South Harbor Rebuild Request for Proposals ADDENDUM # 5

This addendum forms a part of the South Harbor Rebuild Request for Proposals.

Addendum #5 Questions and Answers

1 FIXED BOOM CRANE ⚠

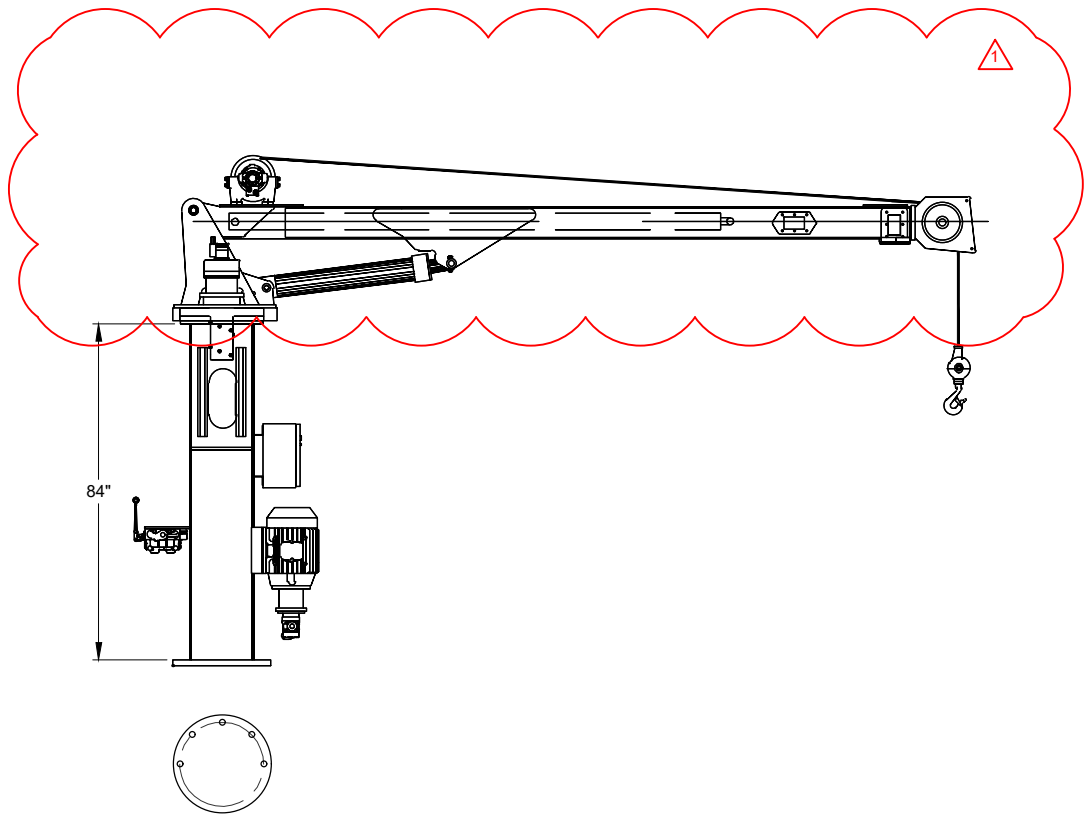
Please confirm the requirements of the pedestal crane. The specifications in the drawings call out a 5-ton hydraulic crane (rated at 10’ radius) and a maximum as-rigged lift at 10’ radius of 4,000 lbs (2 tons). These values appear to be in conflict.

Provide a marine pedestal crane with a 5-ton lifting capacity at 10-ft from the edge of the dock. See revised drawings S3.

FURNISH AND INSTALL 5 TON HYDRAULIC CRANE, MINIMUM CRITERIA LISTED BELOW:

- CRANE CAPACITY: 10,000 LBS @ 10 FEET MIN. ⚠
- MAX. BOOM ANGLE: 78 DEGREES
- SLEWING ANGLE: 360°, CONTINUOUS (STANDARD)
- SLEW SPEED: ~1.0 RPM
- CONTROLS: PEDESTAL-MOUNTED CONTROLS
- MOTOR: 20HP 3Ø ELECTRIC
